#### 1.0 Purpose of Visit

- 1.1 Sam Margrave Jones *MEng CEng AlStructE*, of Symmetrys attended site at 8:15am of the 16<sup>th</sup> August 2024 to carry out a pre-pour review of the proposed reinforced concrete (RC) ground bearing slab.
- 1.2 At the time of inspection, the weather was clear and dry.

### 12 Ingestre Road

Photograph 4 – RC32/40 concrete and 50mm Bottom cover confirmed. Note cover photo was taken following comments from structural engineer.

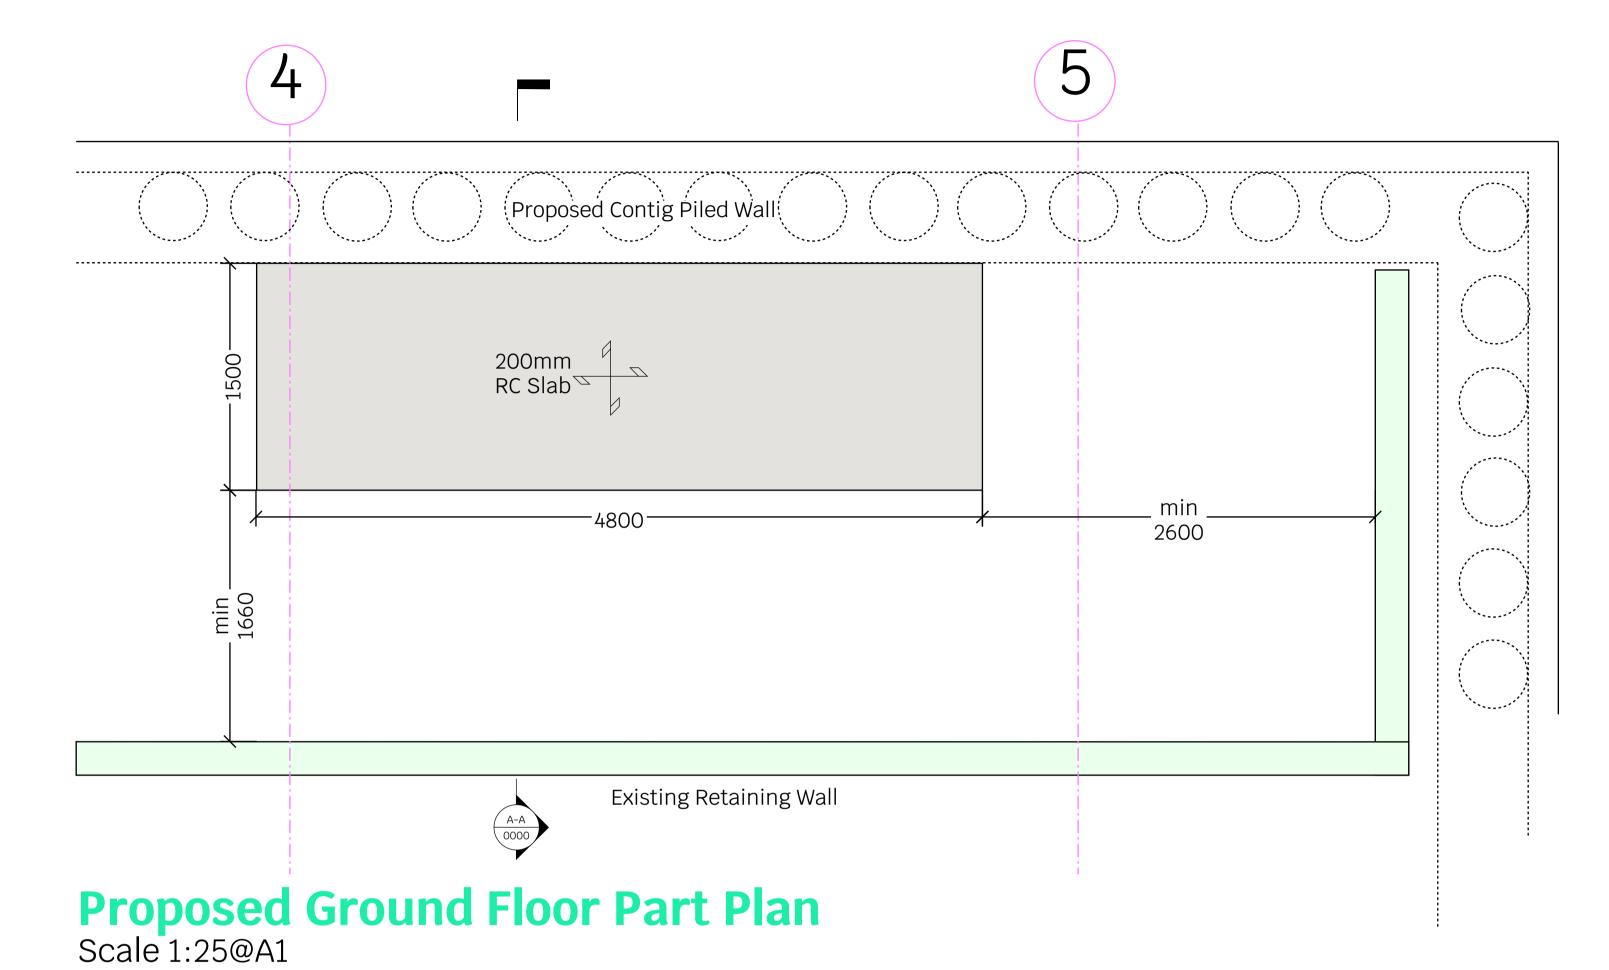
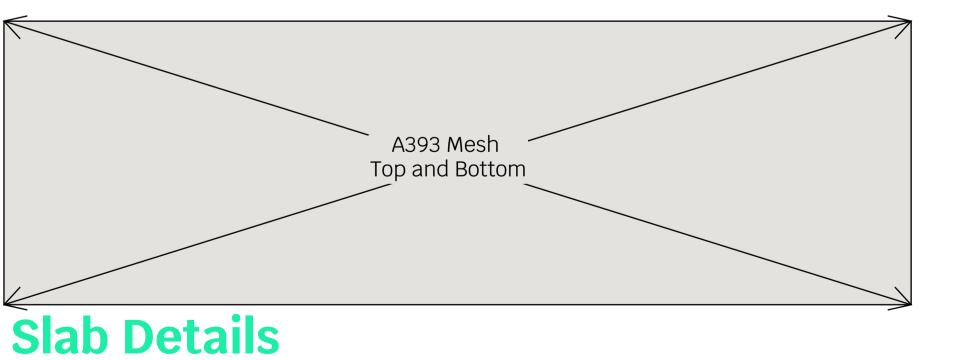
- 2.2 Bottom cover was provided via fragmented 50mm concrete pavers. Top cover was provided via makeshift chairs formed from reinforcing offcuts.
- 2.3 In 1No. localised location, the bottom cover was noted slightly low at c.35mm. The contractor made the appropriate amendments to the bottom mesh during the engineer's visit.

Location/ Reference	Observation	Photo Ref	Proposed Next Step	Closed/Open
Rebar Bottom Cover	As-drawn bottom cover is 50mm. Local areas of 35mm cover were noted by the engineer. Cover was increased immediately by the concractor.	Photo 4	None required. Cover increased during site inspection.	Closed
